Addendum Number One

Date of Issue: October 6, 2025

Project: MTC – CE BUILDING RENOVATION HARBISON CAMPUS

Project Number: H59-6330-PD

1 REFLECTED CEILING PLAN
1/4" = 1'-0"

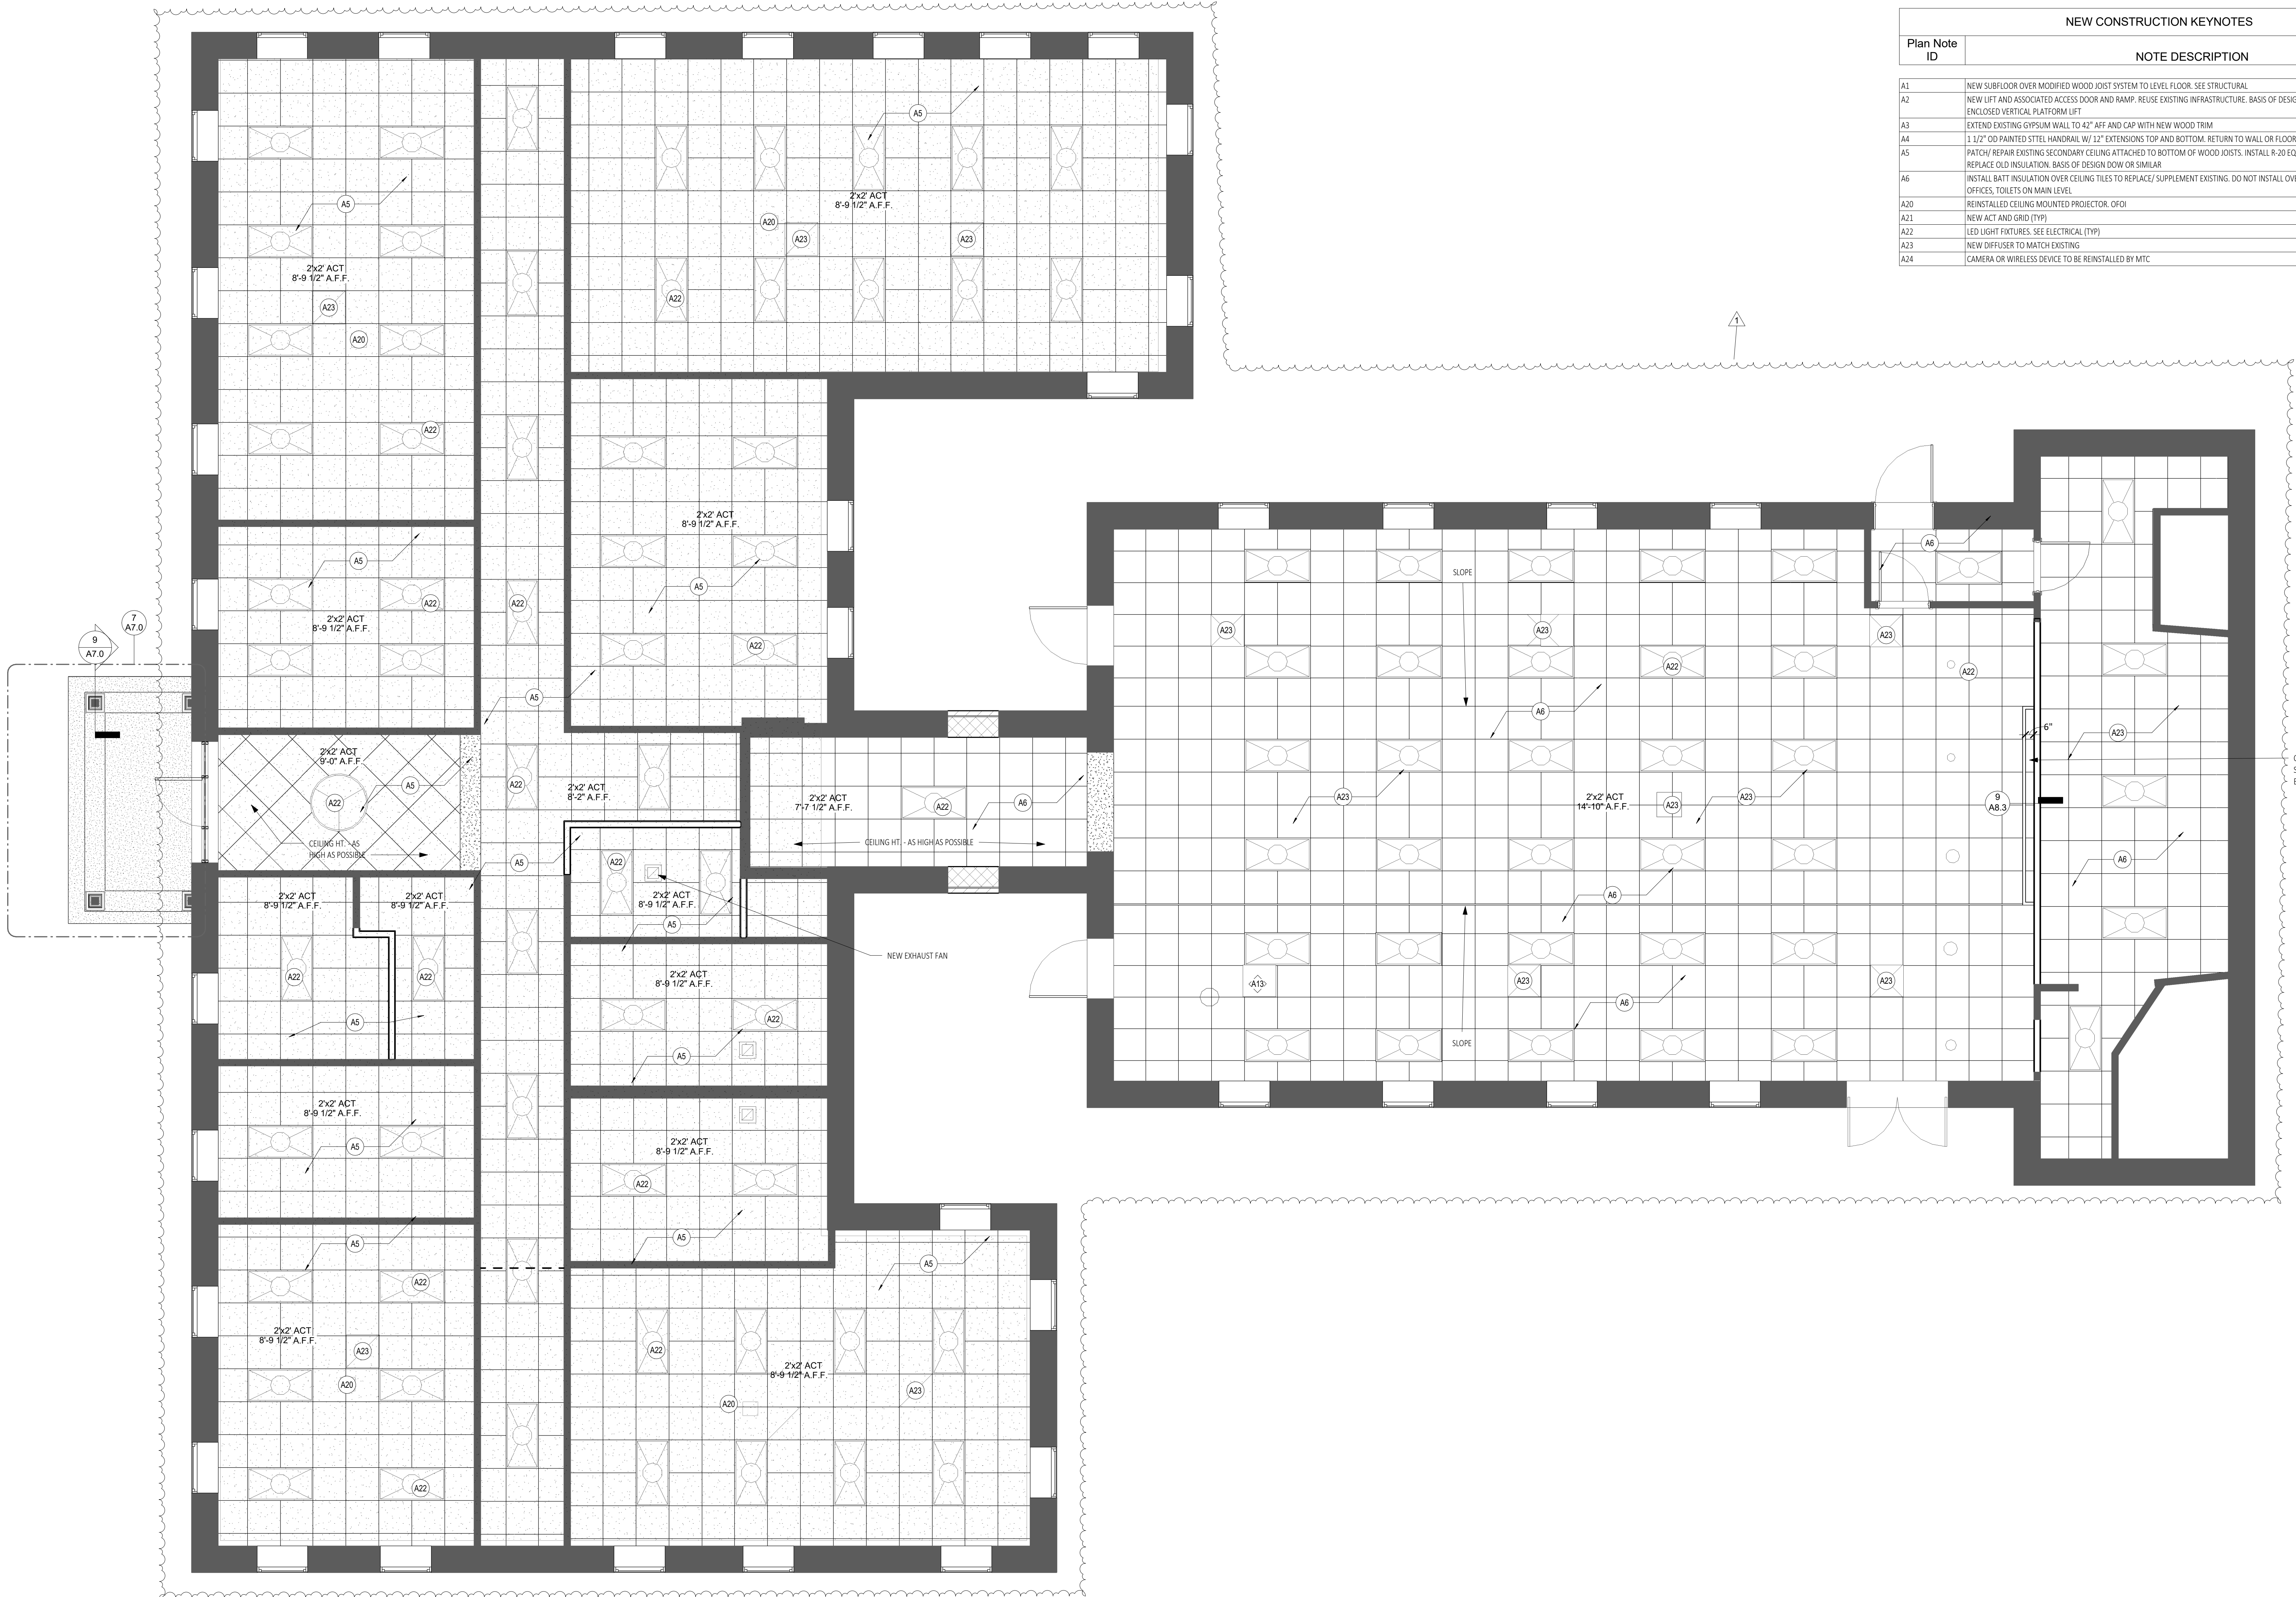
Item No.	Description
5.	Remove and replace existing Sheet "A3.1- Reflected Ceiling Plan" with the attached Sheet "A3.1-Reflected Ceiling Plan- Revision 1", dated 10.06.25 .

1 10.06.25 REVISED KEYNOTES TO CLARIFY ABOVE CEILING INSULATION
